SILM ELECTRONICS
 06A419-03
 REV. 3 PM6

SVT-CL AND
SVT-2PRD

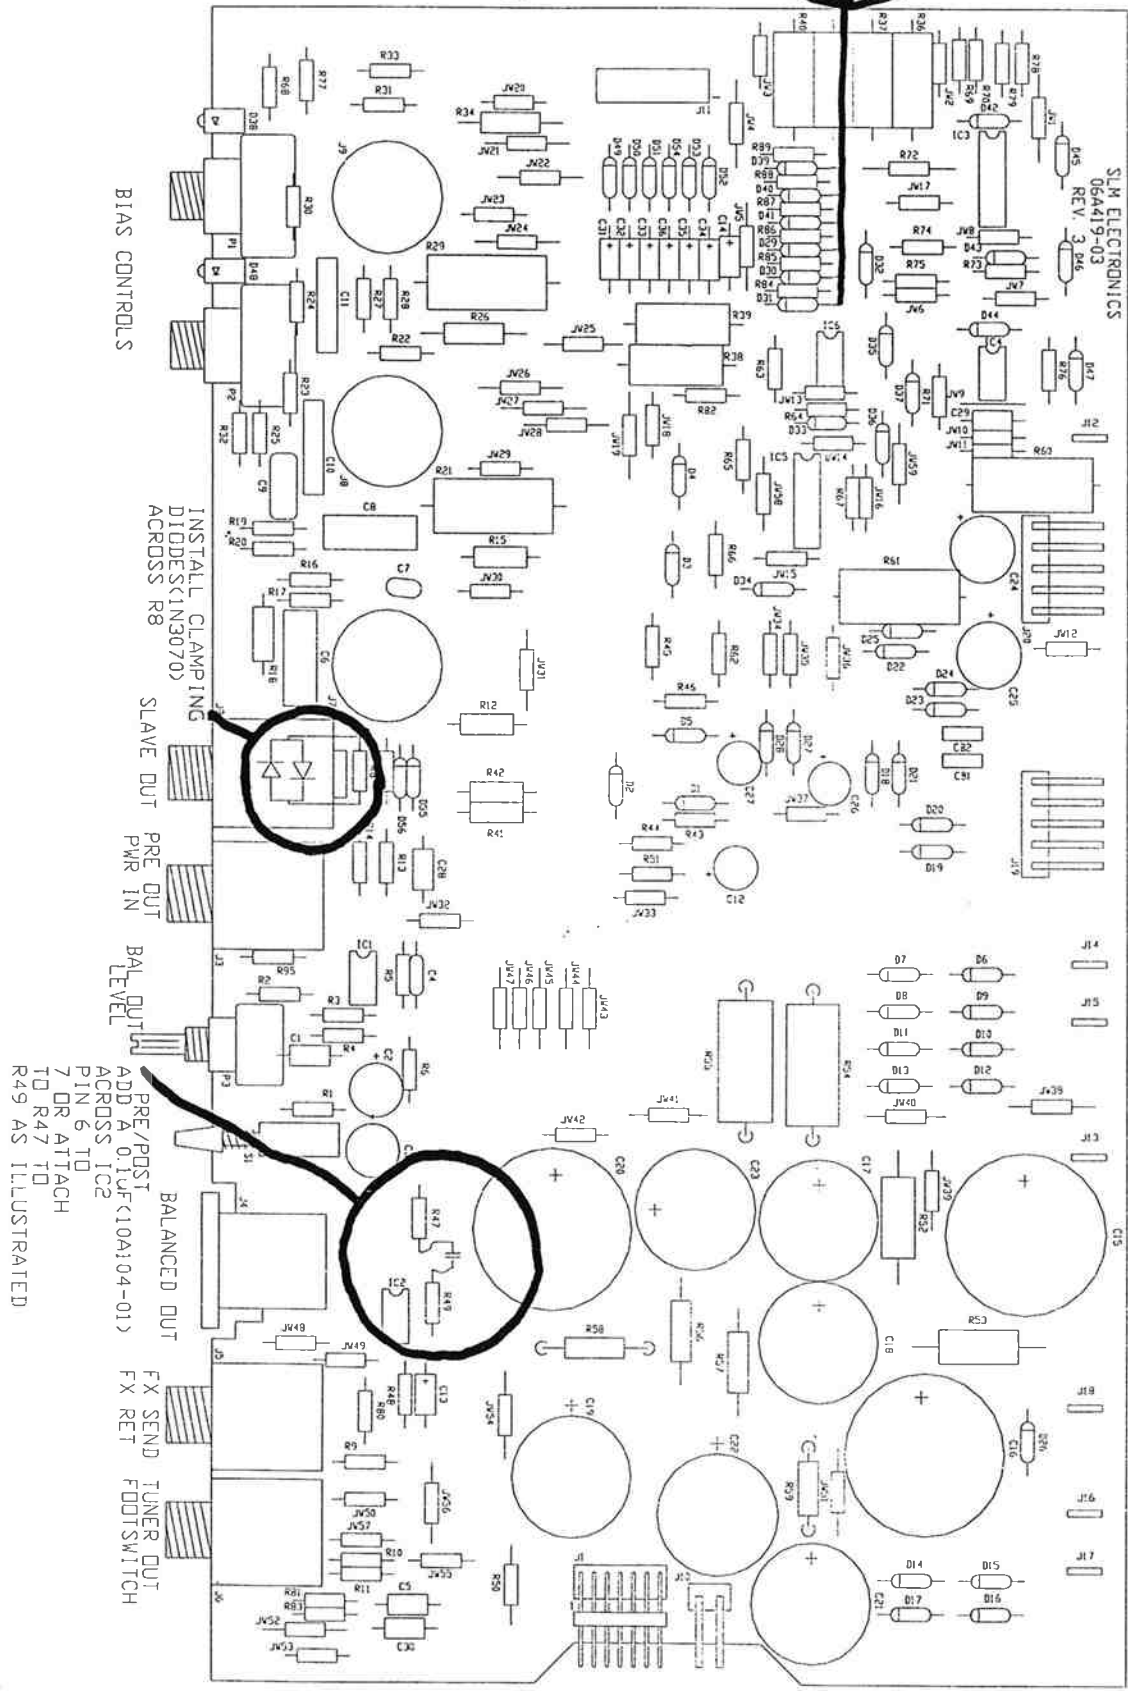
D39, 40, 41
 D29, 30, 31
 CAN BE
 SUBSTITUTED

CHANGE THESE
 IN 3070 DIODES
 TO IN4007

INSTALL CLAMPING
 DIODES (IN3070)
 ACROSS R8

PRE/POST
 ADD A 0.1uF (<10A> 04-01)
 PIN 6 TO
 7 OR ATTACH
 TO R47 TO
 R49 AS ILLUSTRATED

* ALSO - ON P.C.B ASSY ~~07-319-03~~
CHANGE R1 TO 68K 1/4w (7C-683-01)

R7
R8

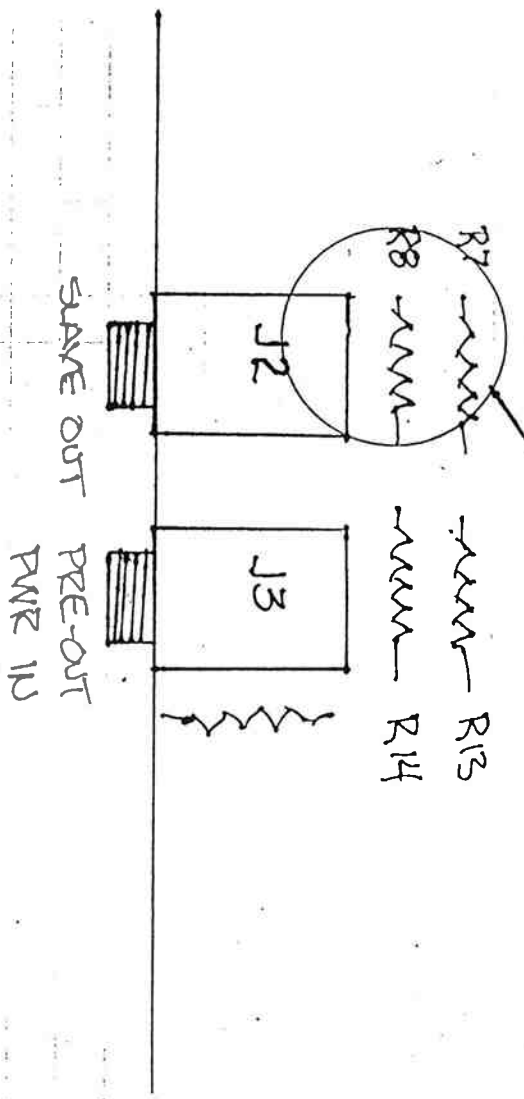
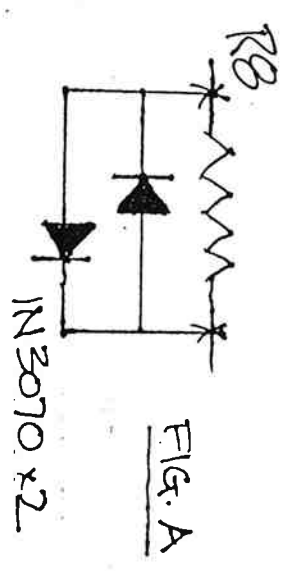
ADD (2) IN3070 (21A370-01) DIODES
BACKWARDS FROM EACH OTHER IN
PARALLEL WITH R8 (FIG. A)
